From: Seeds, Tena (ECY)
Sent: Tuesday, October 28, 2025 9:12 AM
To: 'Lea Kane'
Cc: John Moshy; Melissa Asher; Hannah Cohen
Subject: RE: 700 Dexter - IAWP Location Changes

From: Lea Kane <Lea.Kane@Geosyntec.com>
Sent: Tuesday, October 28, 2025 8:51 AM
To: Seeds, Tena (ECY) <TSEE461@ECY.WA.GOV>
Cc: John Moshy <john.moshy@biomedrealty.com>; Melissa Asher <MAsher@Geosyntec.com>; Hannah Cohen <Hannah.Cohen@Geosyntec.com>
Subject: 700 Dexter - IAWP Location Changes

IA Expansion Phase 1 Layout B-B' (Alley)

Interim Action Work Plan Addendum #3
American Linen Site
Seattle, Washington

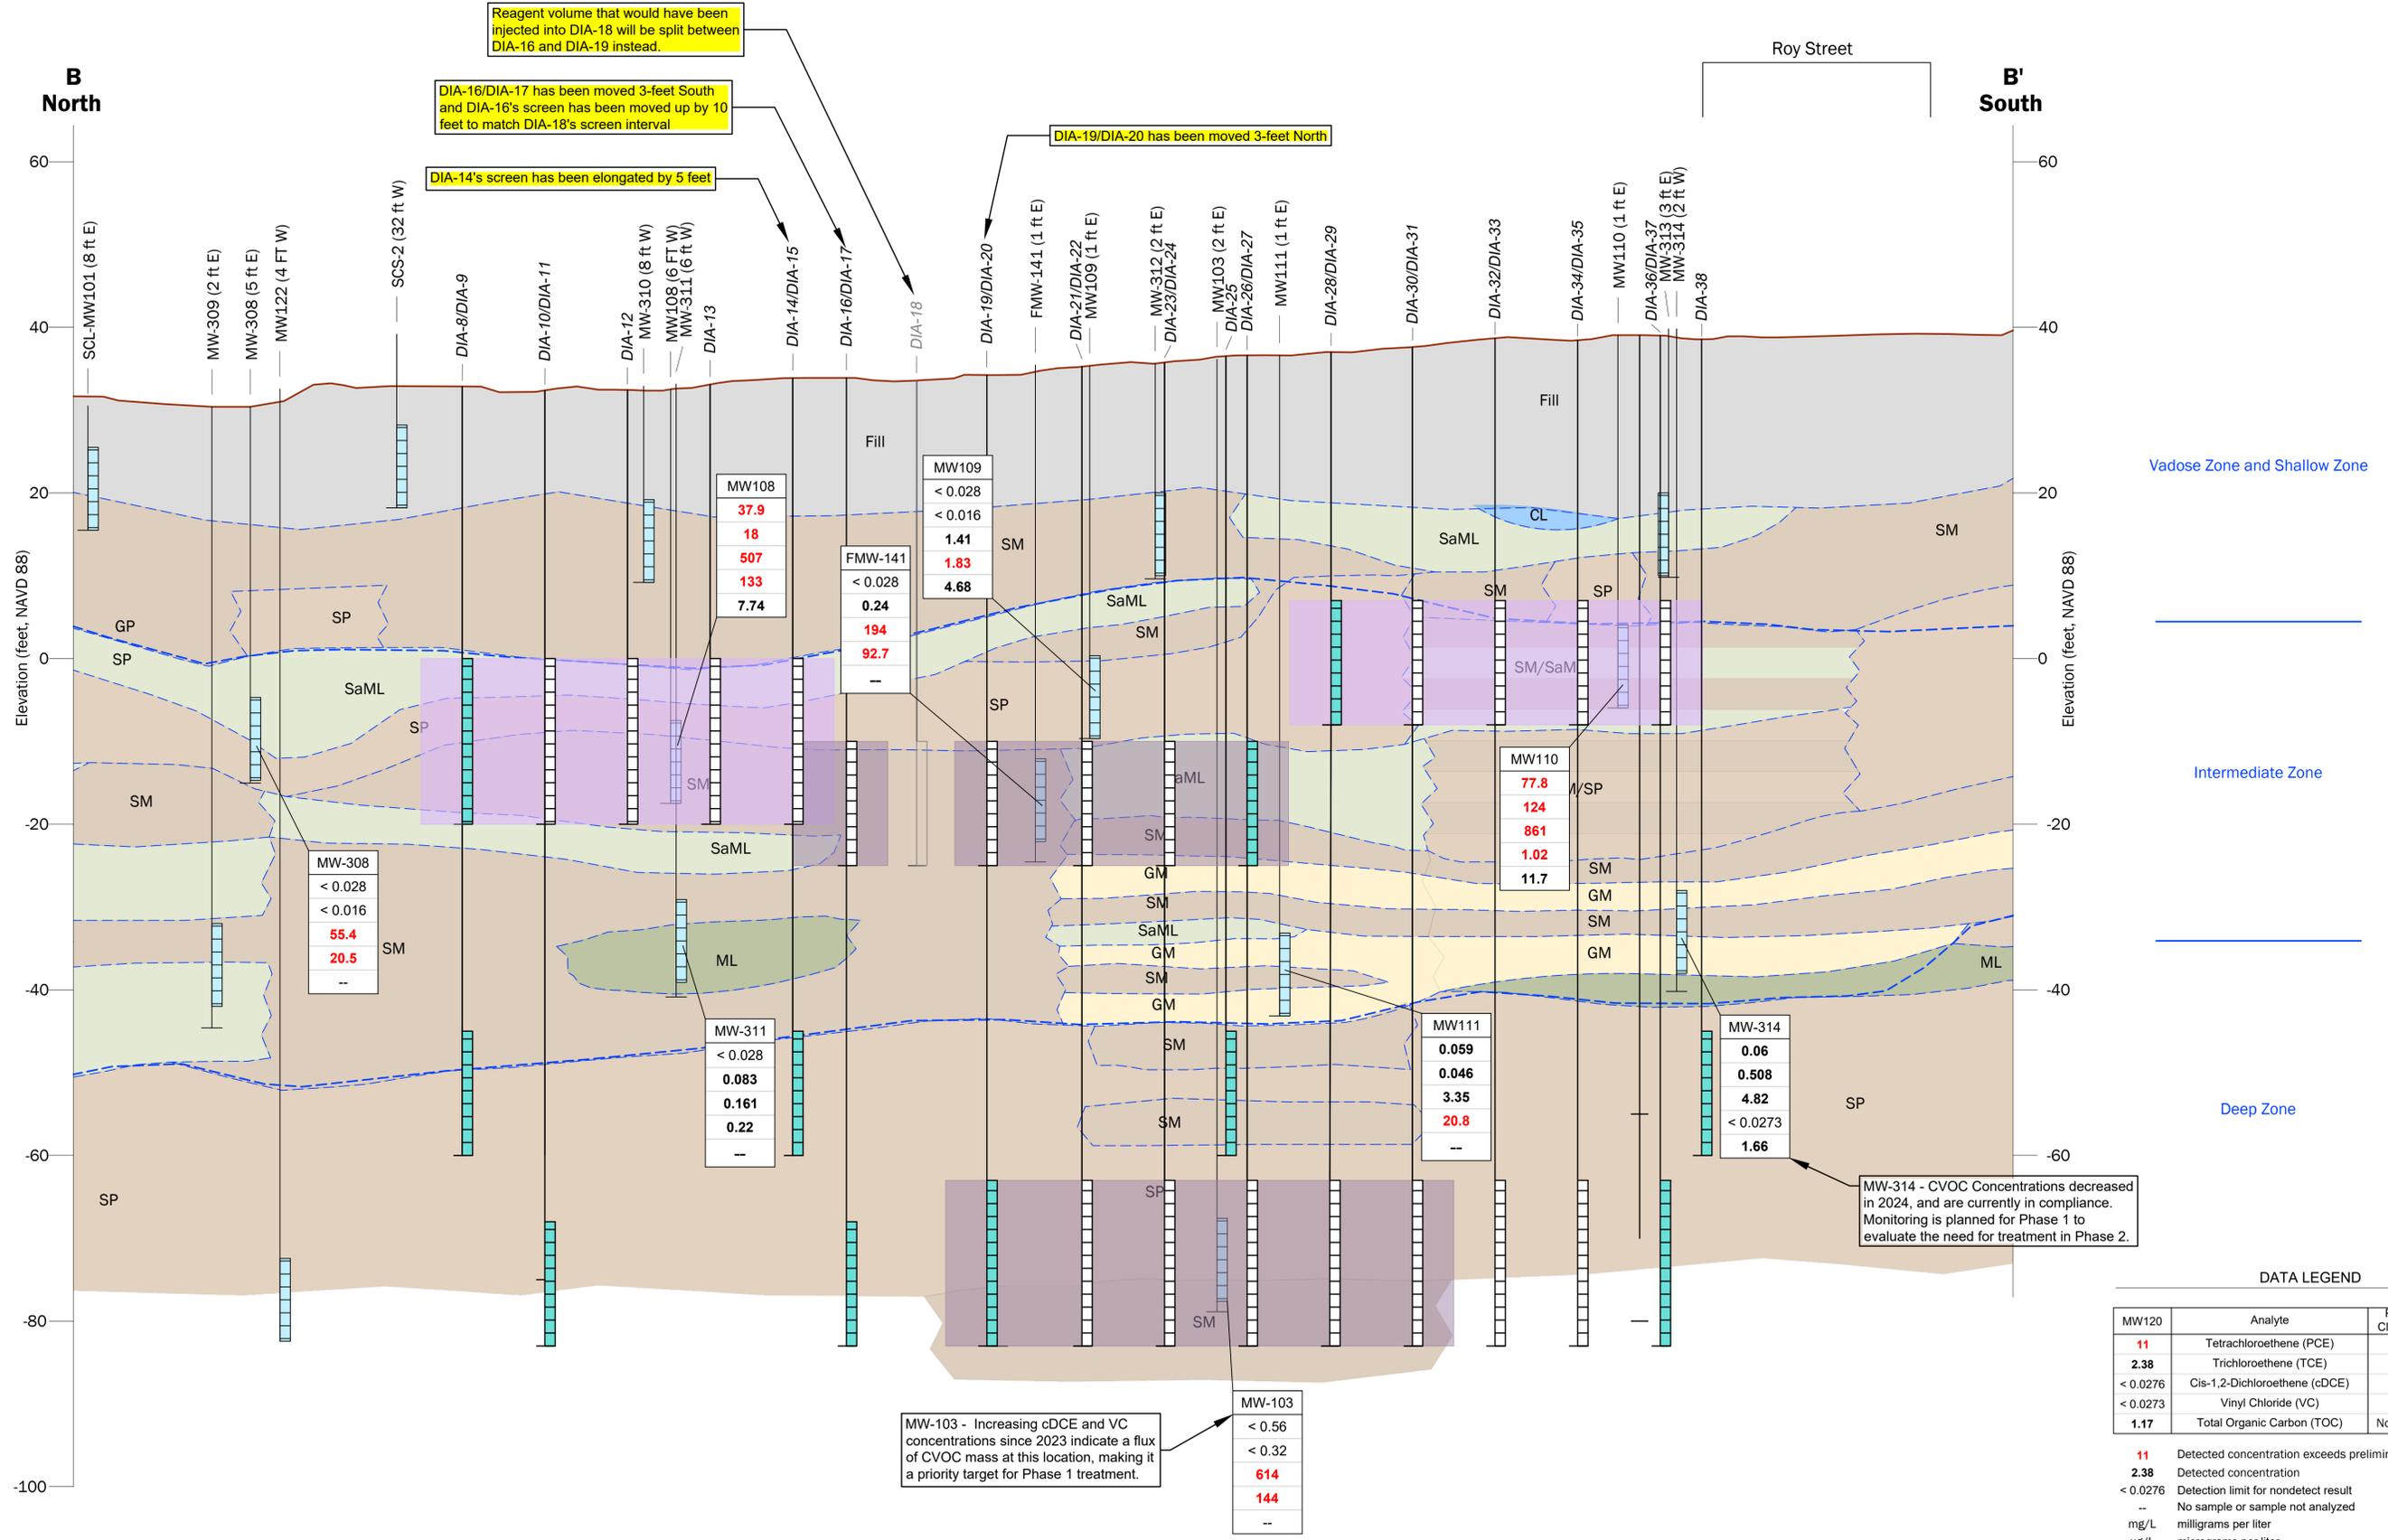
2. Remove Intermediate B Zone injection well DIA-18 from the Alley alignment. After reviewing underground and overhead utility locations in the Alley, we could not identify a location for DIA-18 that did not conflict with one or more utilities and moving this well out of the utility area would then put it in close proximity of one of the adjacent locations, leaving a gap in the Intermediate B Zone injection transect.

- In order to make up for the loss of this treatment location, we propose to shift the adjacent well pairs (DIA-16/17 and DIA-19/20) towards the former DIA-18 location by approximately 3-4 feet, elongate the screen of adjacent well DIA-14 by 5 feet, shift the DIA-16 well screen up approximately 5 feet as shown in the attached figure, and inject the reagent volume planned in the design for DIA-18 into adjacent Intermediate B Zone wells DIA-16 and DIA-19.

- Treatment goals will still be met by making these adjustments near DIA-18. By moving DIA-16 and DIA-19 a few feet inward to make up the difference in the gap left by DIA-18 and increasing the injection volume in DIA-16 and DIA-19 by 50%, the radius of influence of the injections into DIA-16 and DIA-19 will increase and still provide coverage of the planned injection transect.

- The location adjustments for DIA-16 and DIA-19 will not impact their respective collocated Deep Zone wells, DIA-17 and DIA-20. These Deep Zone wells will be sampled during the IAWP#3 implementation to collect additional data about the extent of the plume and current geochemical conditions. The data collection goals will still be achieved and will not be affected by the slight change in location.

Reagent volume that would have been injected into DIA-18 will be split between DIA-16 and DIA-19 instead.

DIA-16/DIA-17 has been moved 3-feet South and DIA-16's screen has been moved up by 10 feet to match DIA-18's screen interval.

DIA-19/DIA-20 has been moved 3-feet North

DIA-14's screen has been elongated by 5 feet

Thanks for sending this information to document the necessary changes. Ecology approves of these changes. Please let me know when the permit is received from SDOT and when you anticipate starting the field work after that. Do you need a formal letter, or will this email reply suffice?
